2 - ADDENDUM #31
 3/2/2018
 1 - ADDENDUM #2
 2/22/2018

A NEW REMODEL PROJECT FOR:
SHERWOOD HIGH SCHOOL
 16956 SW MEINECKE ROAD
 SHERWOOD, OR

DRAWN BY: EVK
 CHECKED BY: SWM
 DATE: 1-30-18
 TITLE: PARTIAL HVAC FLOOR PLANS
 SCALE: 1/8" = 1'-0"

SHEET NO:
M-1.1
 1 OF 6

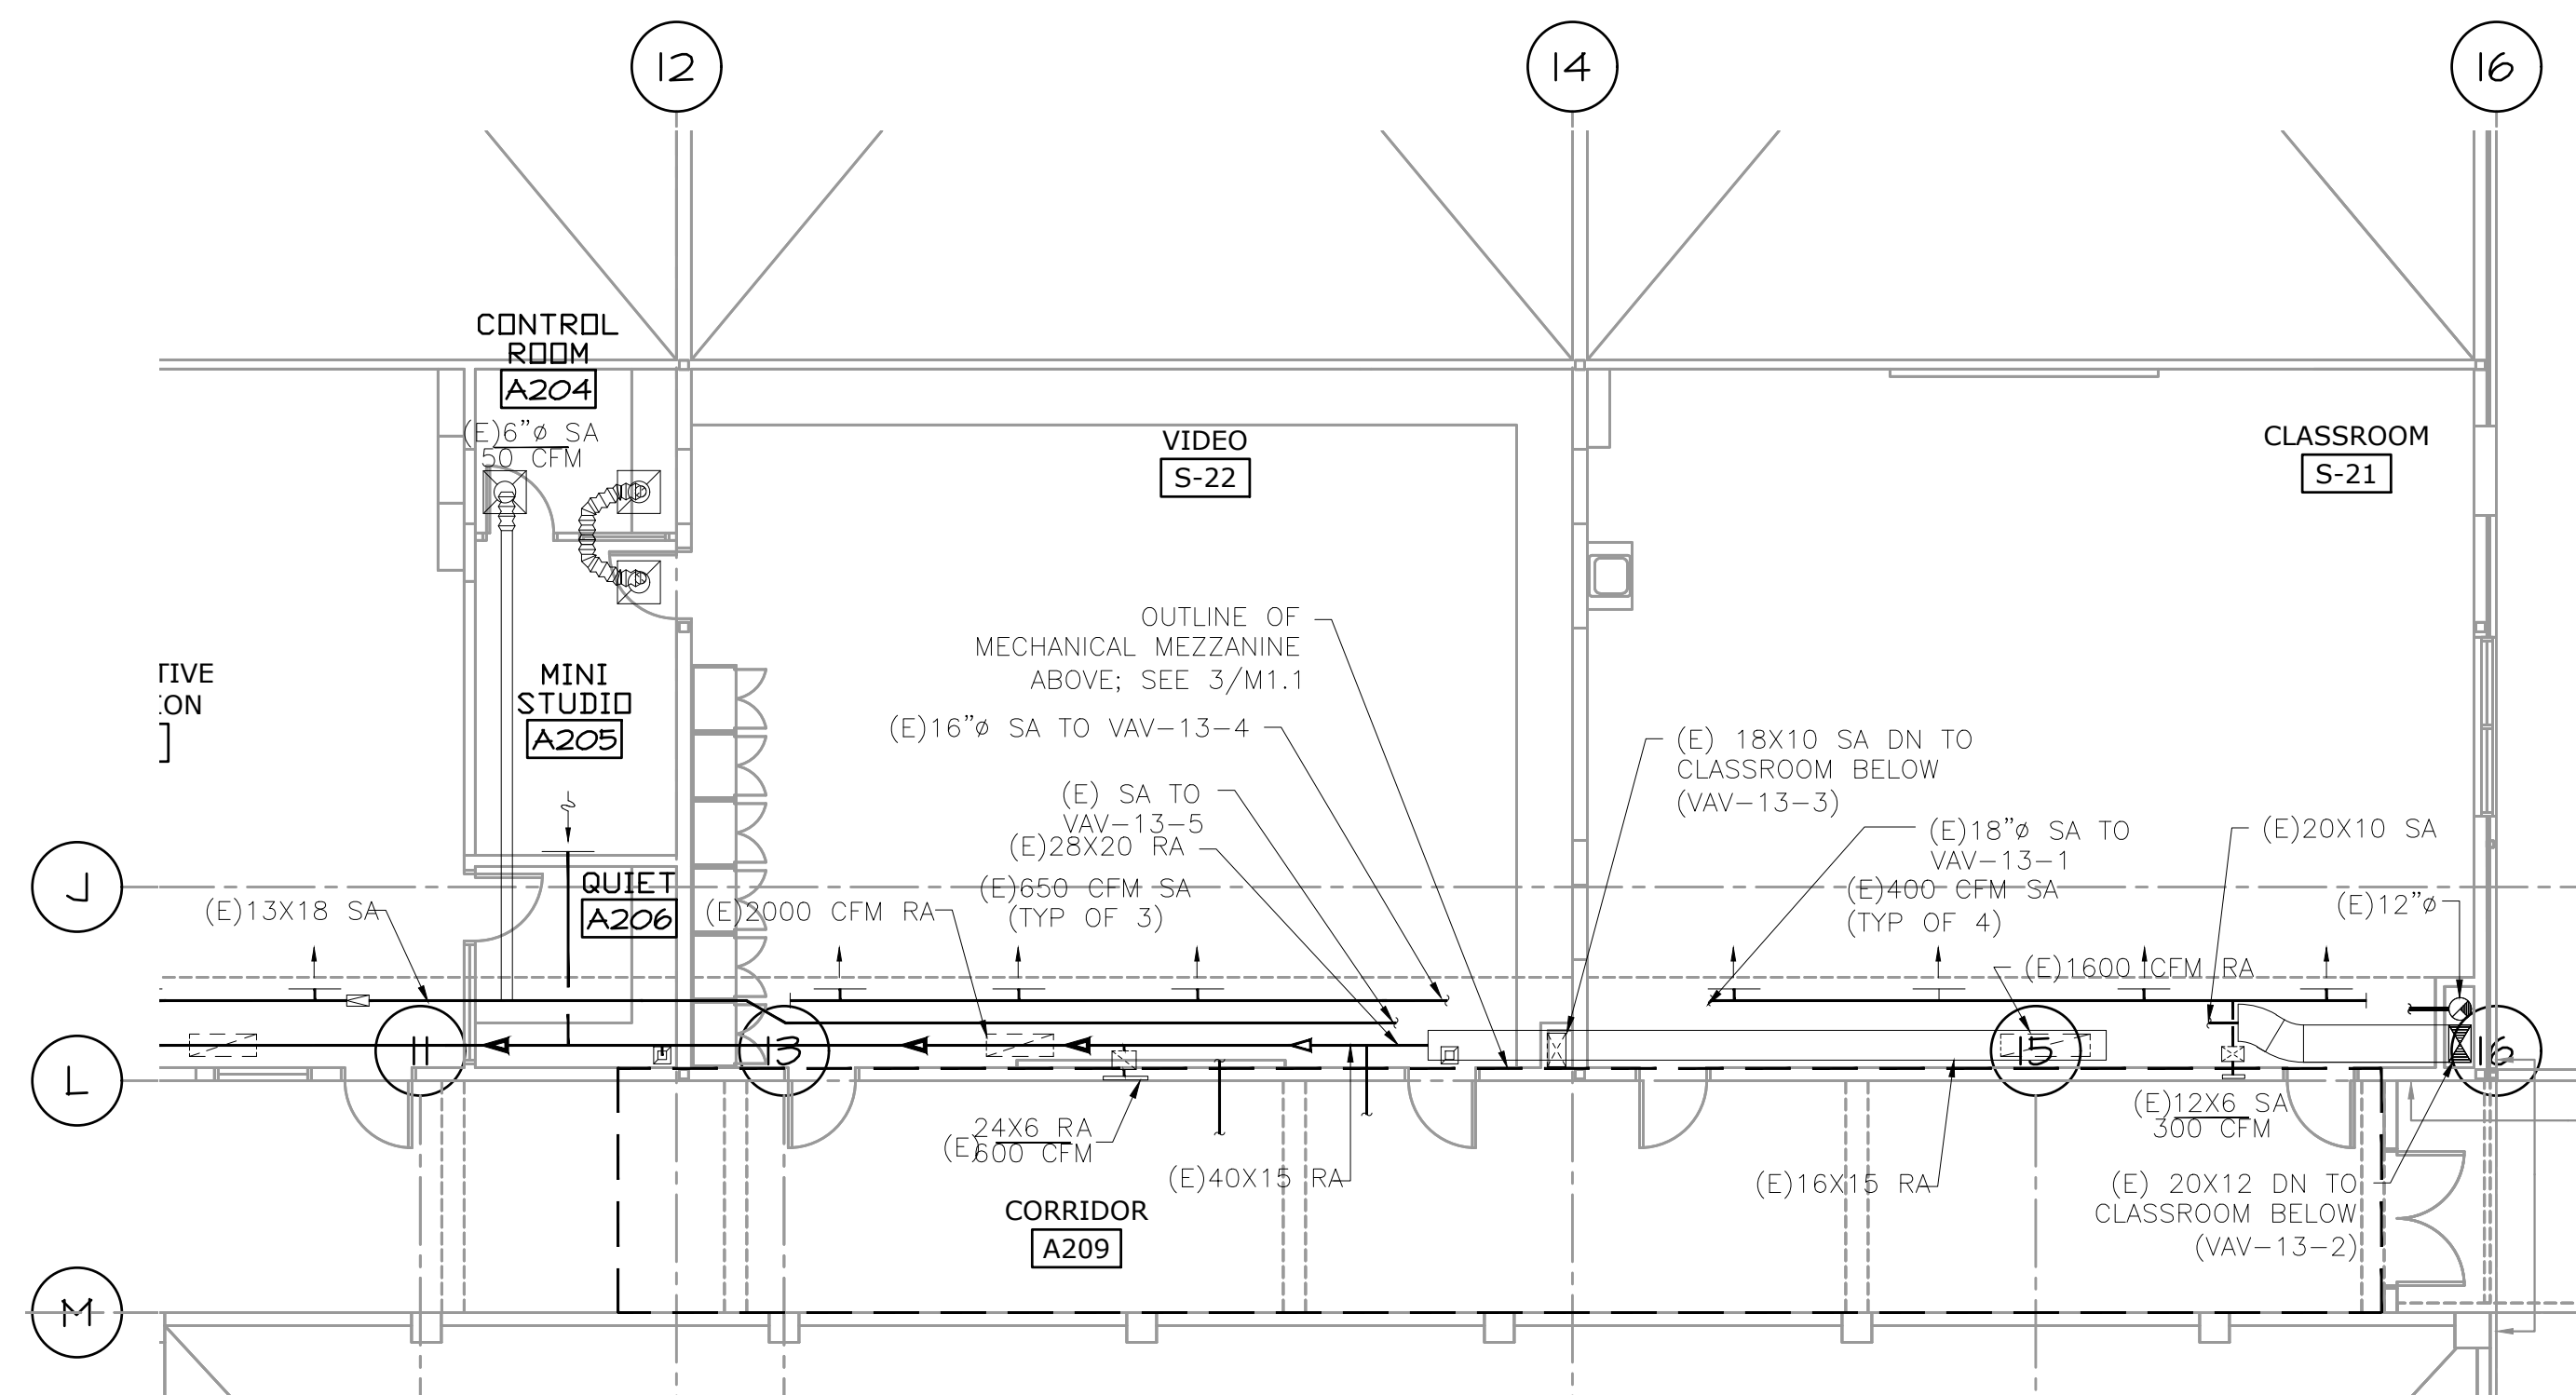
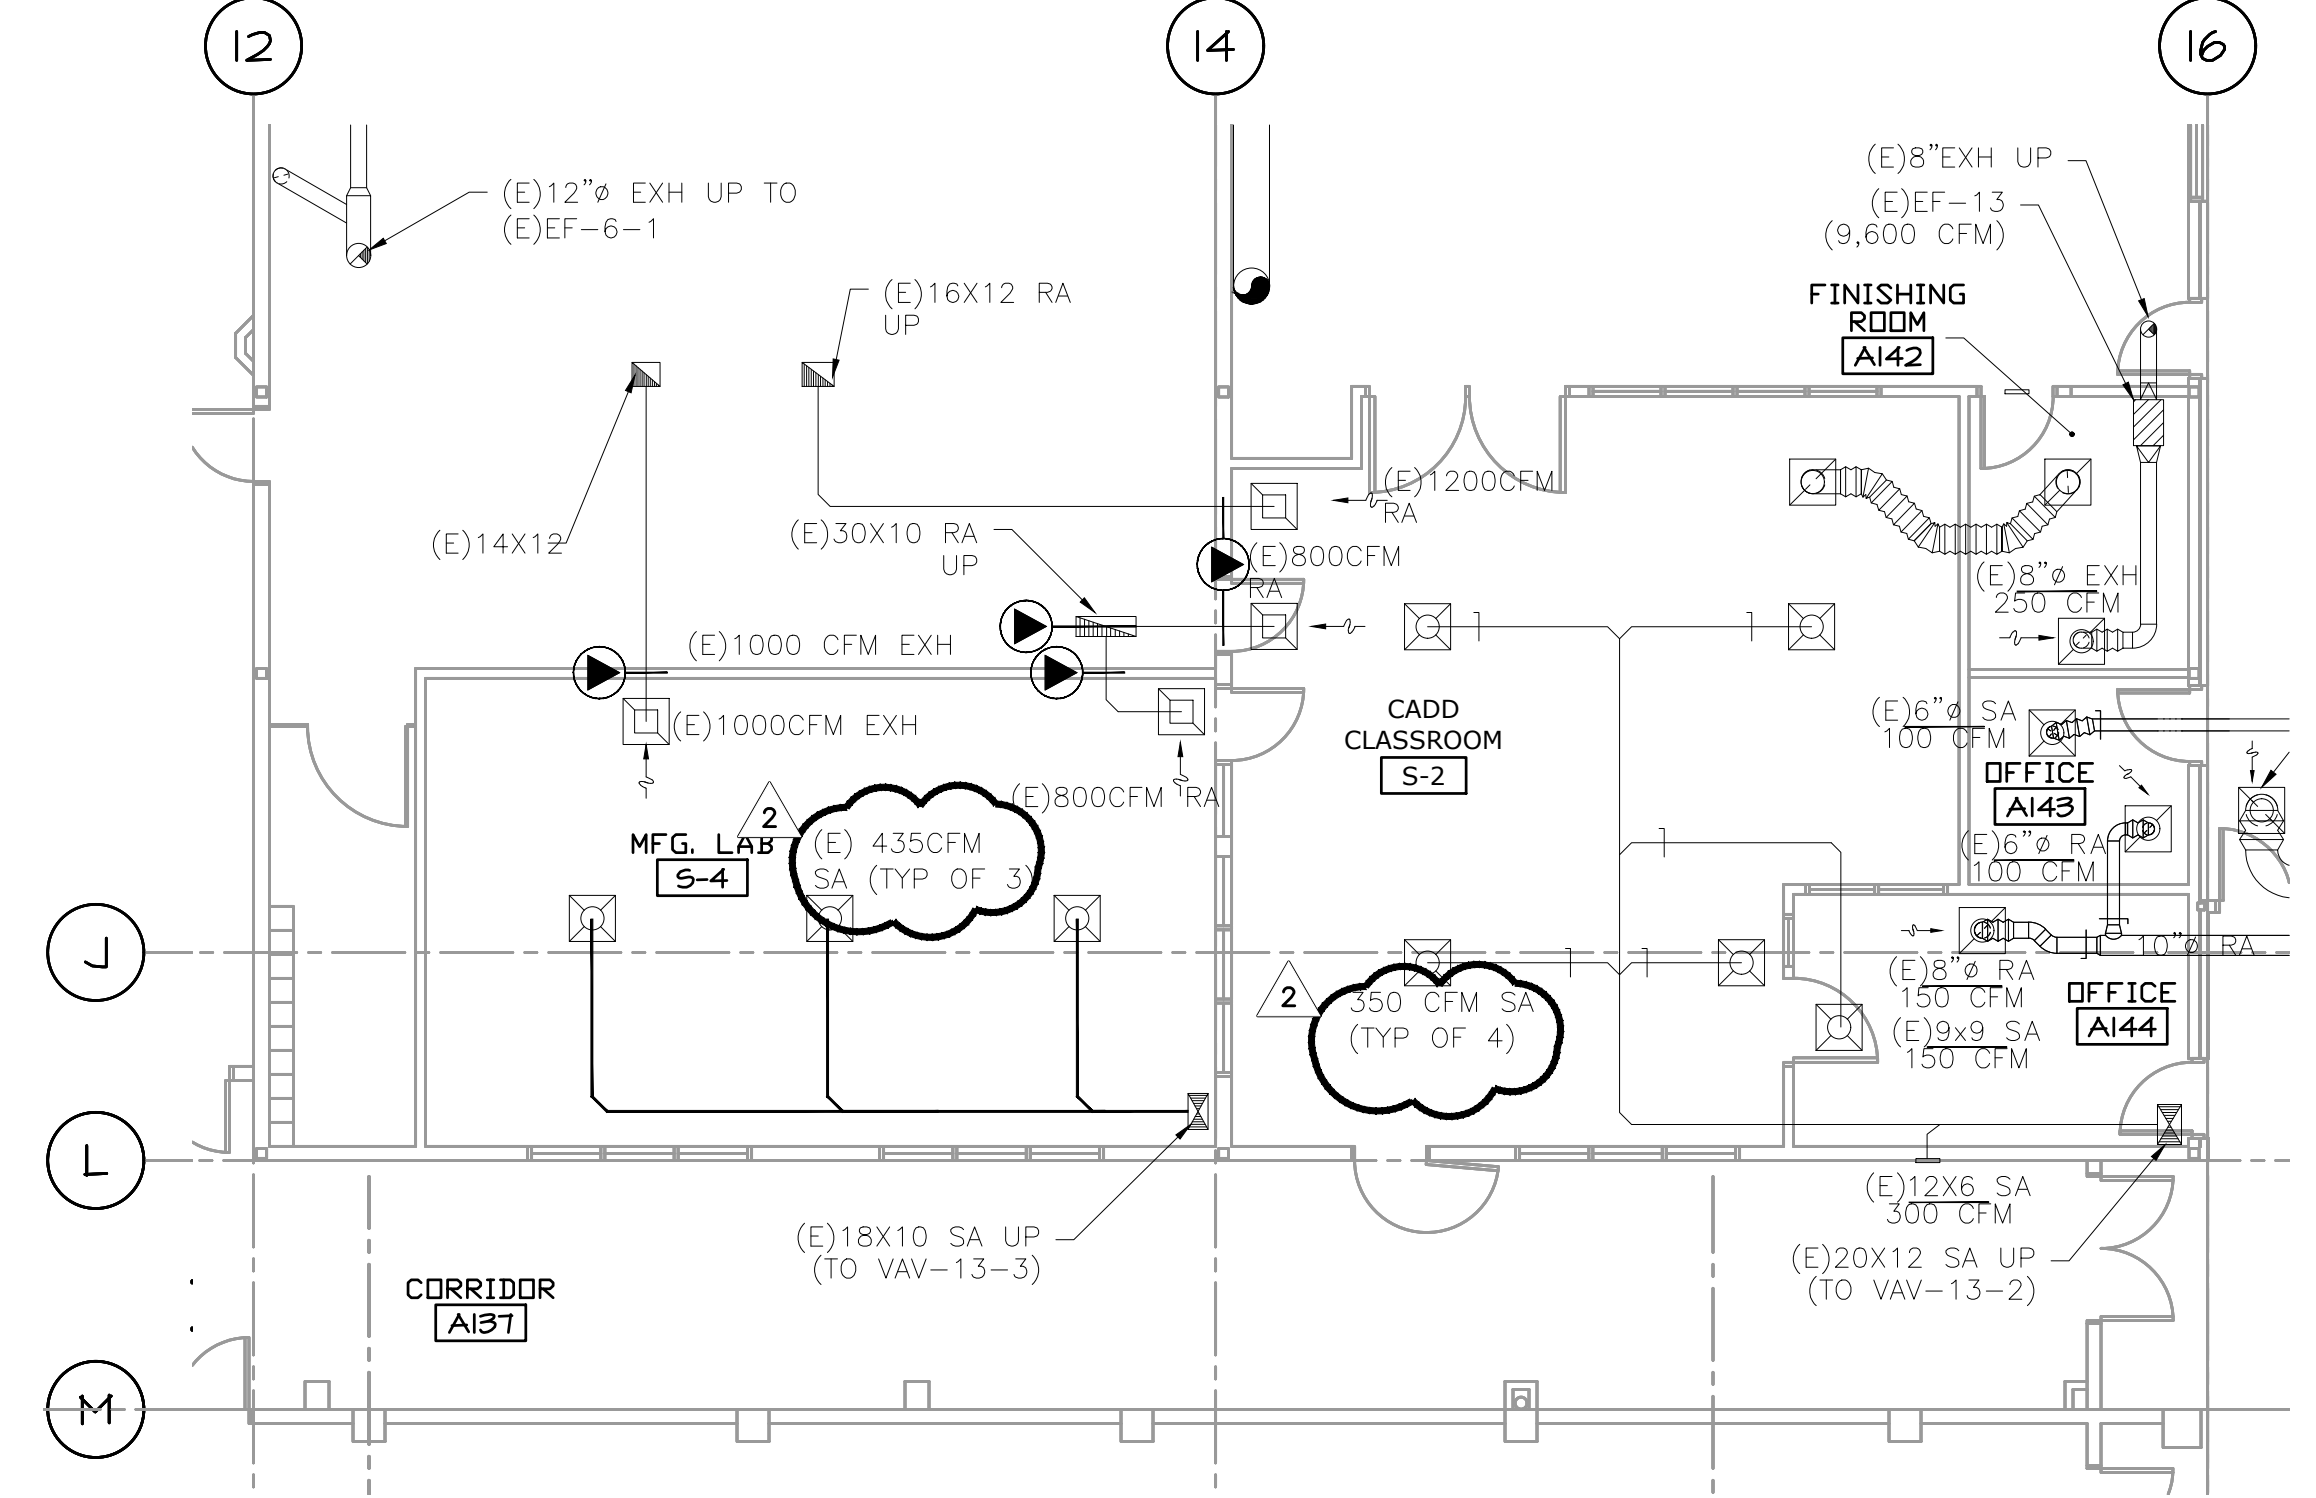
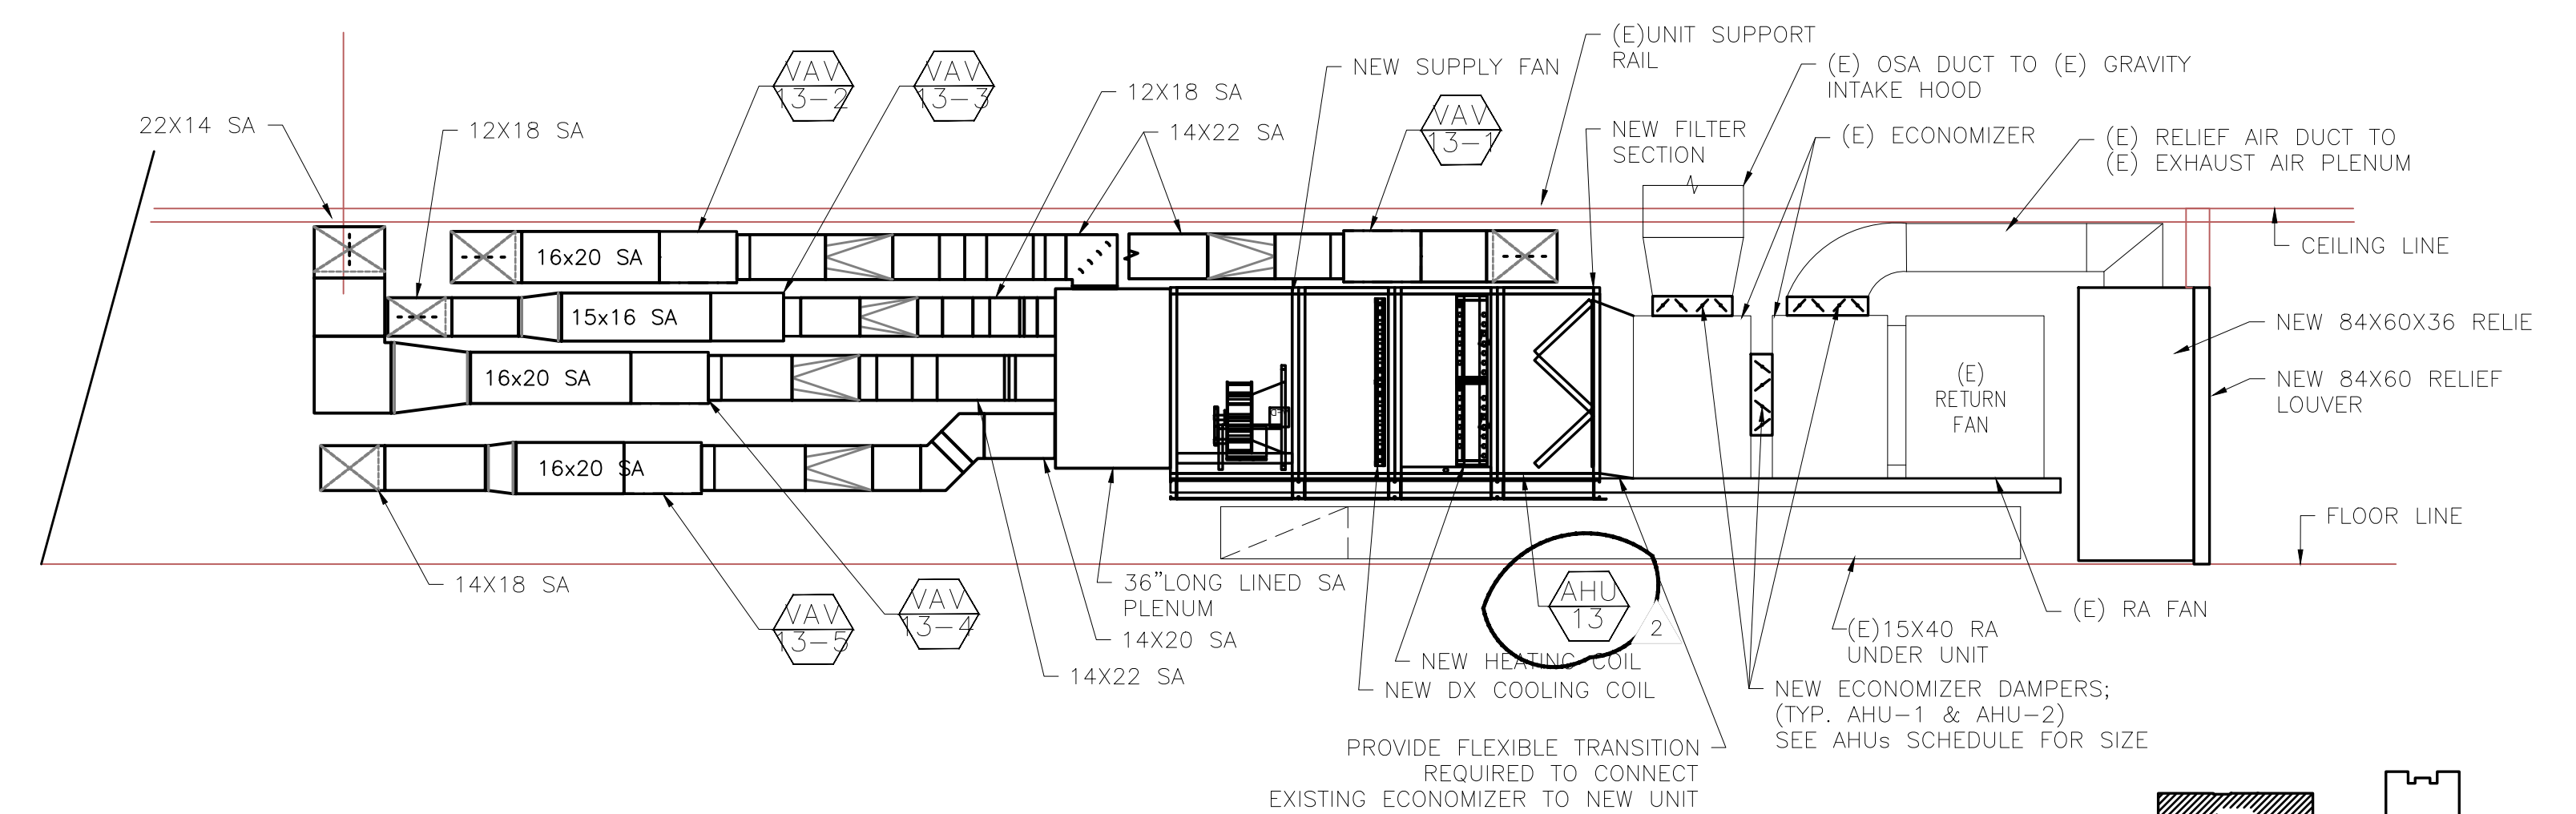
SHEET IS REVISED PER ADDENDUM #2.
